SERVICE BULLETIN

APPLICABILITY: 2011MY Forester
2011MY Impreza WRX and STI

NUMBER: 05-52-12

SUBJECT: Change of Self-Locking Nut and Tightening Torque

- ① and ② : Rear Upper Arm Assy
- ③ and ④ : Lateral Link Assy rear
- ⑤ : Rear Strut Assy

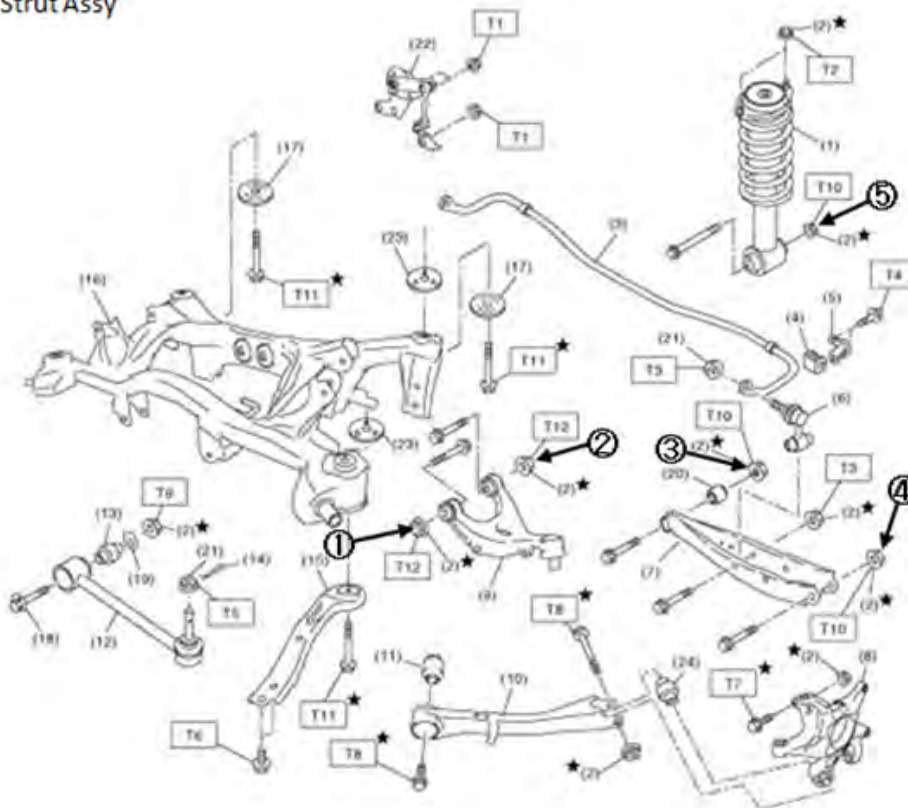
The purpose of this bulletin is to inform you of a change made to enhance vehicle production during the middle of the 2011MY. This change involves the self-locking nuts and tightening torque specifications used on the 5 selected rear suspension components shown in the illustration below.

IMPORTANT: The self-locking nuts used in the 5 locations above are **one-time use** items. If removed, they must be replaced. The old-style nuts are silver in color while the new-style nuts are black. They are NOT interchangeable due to different tightening torque specifications.

When servicing the rear suspension on an applicable **2011MY** vehicle listed, replace any of the referenced self-locking nuts with the self-locking nut specified in the repair parts catalog (which will be the silver lock nuts) regardless of the color removed. In the event you do not remove the nut and only check it for proper tightening torque, follow the recommendations shown in the chart below based upon the color of the nut being checked.

To clarify, if you are **only checking the tightening torque** of the nuts installed on a **2011MY** vehicle, silver nuts should be torqued to the 2011MY specification and black nuts to the 2012MY specification.
